Subject: Objection to the Hitch Rack Ranch Quarry, Permit Number M2017-049

Details related to Objections to the Hitch Rack Ranch Quarry Application

b. Proposed boundary of affected lands.

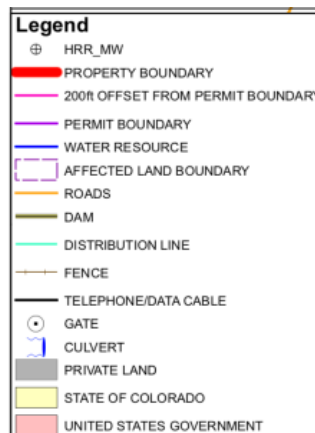
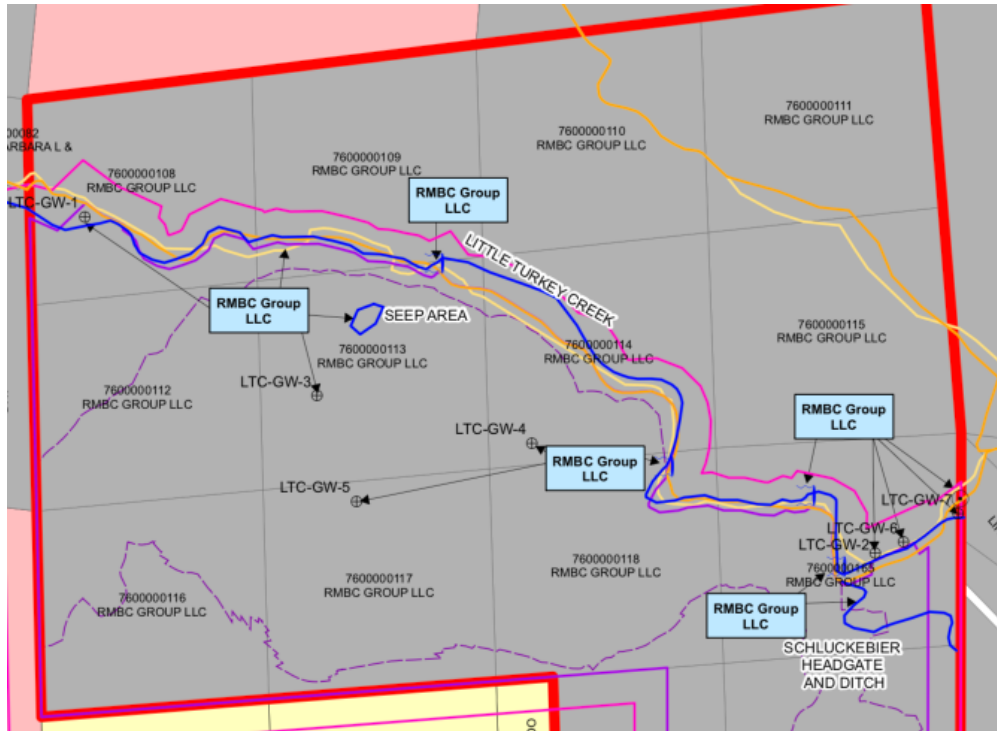
Some of the monitoring wells and blast monitoring equipment associated with the proposed mining operations will be located outside of the proposed affected land boundary.

d. Figure C-2

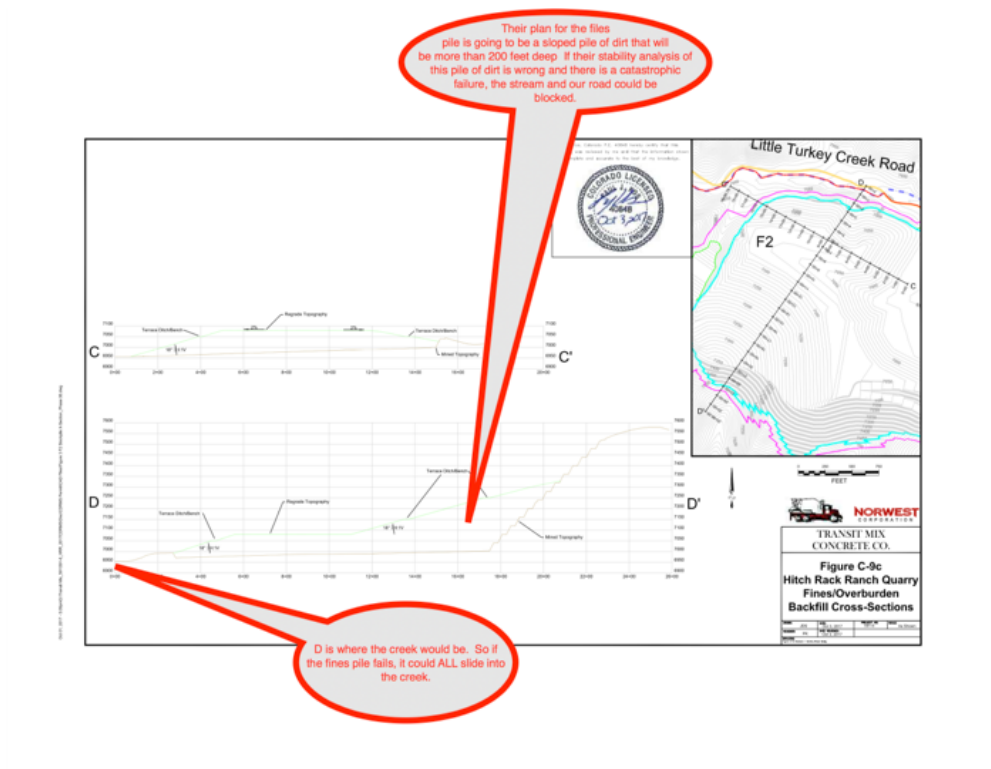
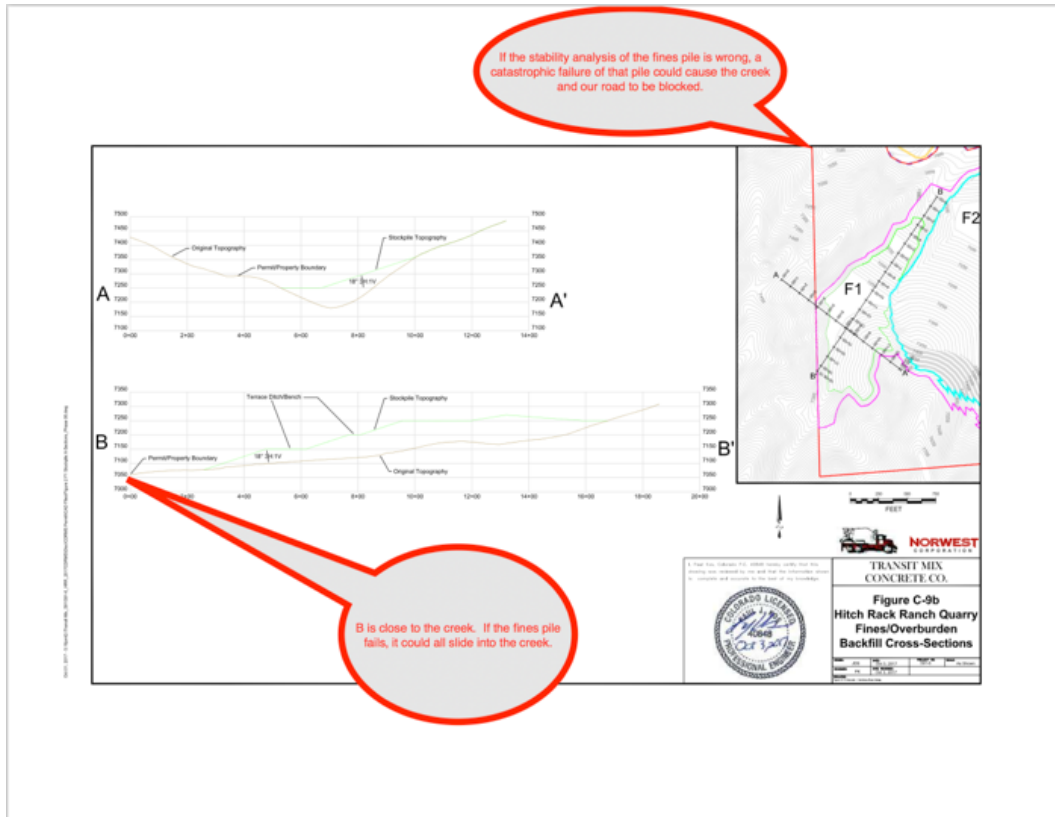
There are numerous omissions and inaccuracies in this map:

- 1) The map includes two different colors for roads within Section 16 (orange and yellow). There are NOT two roads.
- 2) Several segments of the line depicting the northern boundary of the permit area within Section 16 are missing. Knowing the EXACT location of the permit boundary with respect to Little Turkey Creek Road is critical to owners of the road easement.
- 3) A segment of the line depicting the northern boundary of the affected land area within Section 16 is missing. Knowing the EXACT location of the boundary of the affected lands with respect to Little Turkey Creek Road is critical to owners of the road easement.

- 4) There are numerous errors in the depiction of the locations where the road crosses the creek.
- 5) The four culverts marked as owned by RMBC Group are located within the road easement and were installed in 2013 by the Eagles Nest Association.

- 6) The location and the ownership of the gate depicted on the eastern edge of Section 16 are both incorrect.
- 7) Two other existing gates are NOT included in the figure.

- 8) The location and ownership of fences are not included in the figure, although an icon for fences is shown in the legend.
- 9) There is an inconsistency in the location of the monitoring wells between Figure C-2 and Figure 1-1 of NORWEST's "Transit Mix Concrete Co. Hitch Rack Ranch Quarry Surface Water and Groundwater Monitoring Program".

- 10) The depiction of the Schluckebier Headgate and Ditch is totally inaccurate.
- 11) Other water retention and diversion structures within Section 16 are omitted from the figure (e.g., dams, pipelines and ditches).

Figure C-3 (shown below) shows the locations of the test bores drilled in 2014 and 2015.

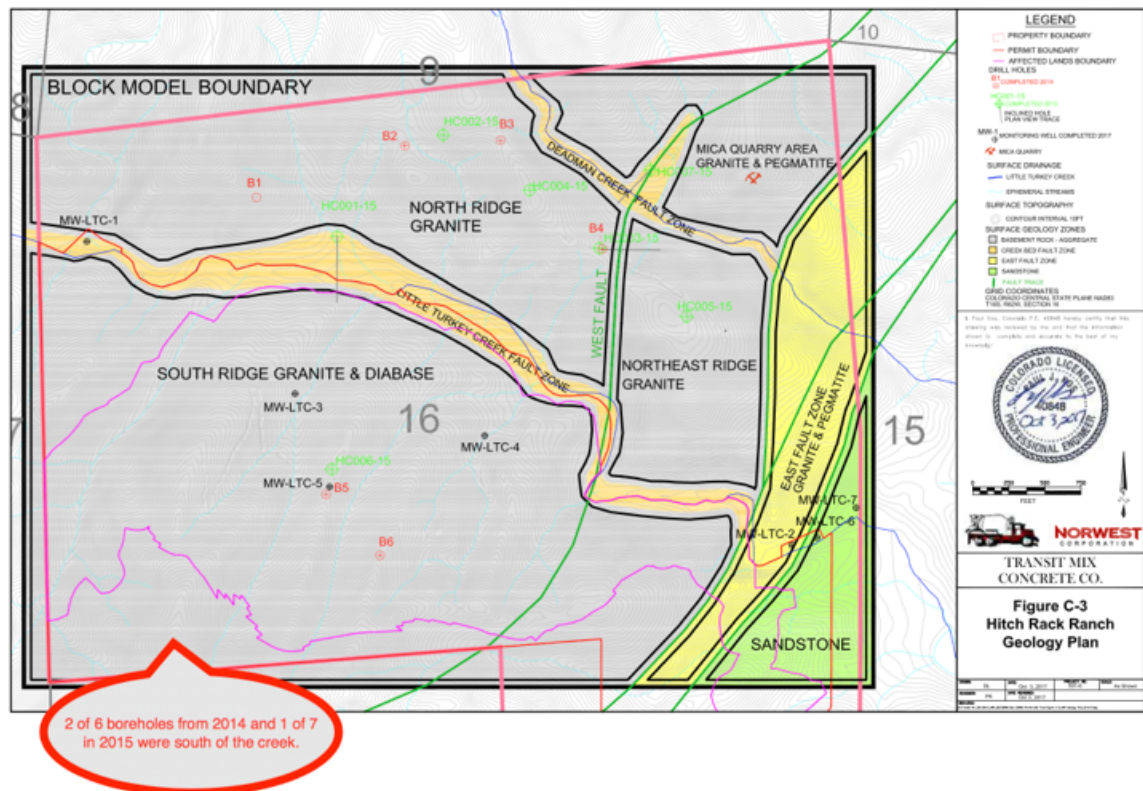
In their stability analysis for the pit walls, (NORWEST Geotechnical Pit Wall Geotechnical Assessment – Rev 0, dated Sept 11, 2017), NORWEST admits that the data collection from the 2014 drilling contained only limited geotechnical information and they therefore did not include data from those holes in their subsequent analysis. They also indicate that only 1 of 7 test bore holes completed in 2015 were drilled south of the creek. On pages 8 and 9 of their report they admit that “limited data is available for the proposed pit area but some aspects of the structural conditions are expected to be similar given the similar rock mass conditions, however additional drilling will be required to characterize the structure of the ultimate quarry pit footprint.”

In NORWEST’s analysis for the 2016 permit (M-2016-010) “Hitch Rack Ranch Pit Wall Geotechnical Assessment – Rev. B”, dated January 26, 2015 the engineer recommended: “Additional geotechnical drilling and analyses are required to confirm conditions prior to mining the area south of Little Turkey Creek.” In the transcript from the October 2016 Board Hearing, the CDRMS staff indicated “we have a commitment in the application that before they open that south pit, there’s going to be a lot more research done” (Page 8974 of the Administrative Record).

Transit Mix did not follow the 2016 recommendation of their engineers and has failed to meet the commitment made in the 2016 application to perform more analysis before the south pit is opened for mining. Analysis and conclusions of stability analysis for this permit are therefore primarily based on data taken from bore holes that aren’t even located within the area to be mined and yet the engineering analysis proceeded as though the data being used was a sufficient sample on which to draw their conclusions. If the pit wall stability analysis done by Transit Mix’s engineers for this quarry is based on inadequate data and ends up being *wrong*, there could be a catastrophic failure of the pit walls.
